ARCHITECTURAL CASEWORK
SHOP DRAWING SUBMITTAL

Section 06 41 00 Architectural Wood Casework

PROJECT	**Sample Day Spa casework**
ADDRESS	**300 Example Rd**
OWNER	**Sample Owner LLC**
ARCHITECT	**Sample Architects**
GENERAL CONTRACTOR	**Sample GC**
SUBMITTED BY	**Sample Casework Co., 100 Main St, Anytown**
SPEC SECTION	**06 41 00 Architectural Wood Casework**
SUBMITTAL NO.	**01, revision 0**
DATE	**10/28/2026**

SD-200	CW-02 Restroom vanity and corridor paneling - cover sheet & index
SD-201	CW-02 Restroom vanity and corridor paneling - plan, elevations and notes
SD-202	CW-02 Restroom vanity and corridor paneling - sections and details
SD-203	CW-02 Restroom vanity and corridor paneling - questions for the architect (RFIs)

SD-201

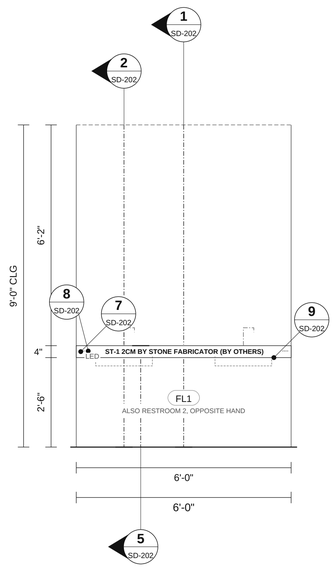
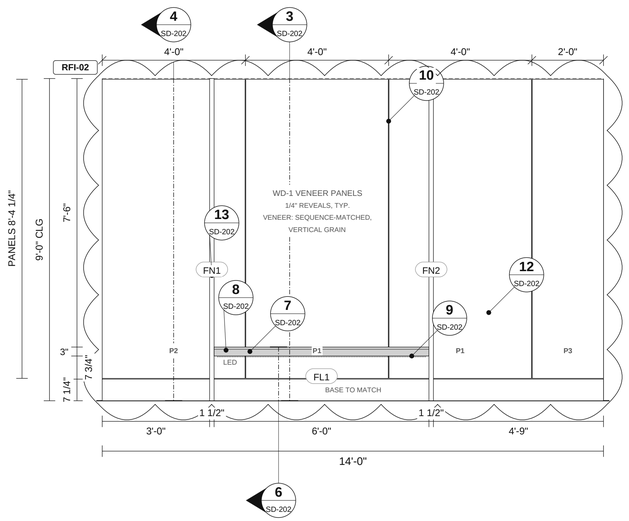
RFI	QUESTION (CONFIRM ...)	STATUS / ANSWER BY	CITED ON SHEETS	RESPONSE
GENERAL (THIS ITEM AND OTHERS)				
RFI-01	Confirm the in-wall blocking for the vanity brackets: continuous blocking at the bracket height, by GC. Confirm the vanity rim height.	**BY SAMPLE GC. OPEN**	SD-202	
RFI-02	Confirm the corridor wall length at the far end; the panel layout puts the remainder panel there.	**BY SAMPLE ARCHITECTS. OPEN**	SD-201
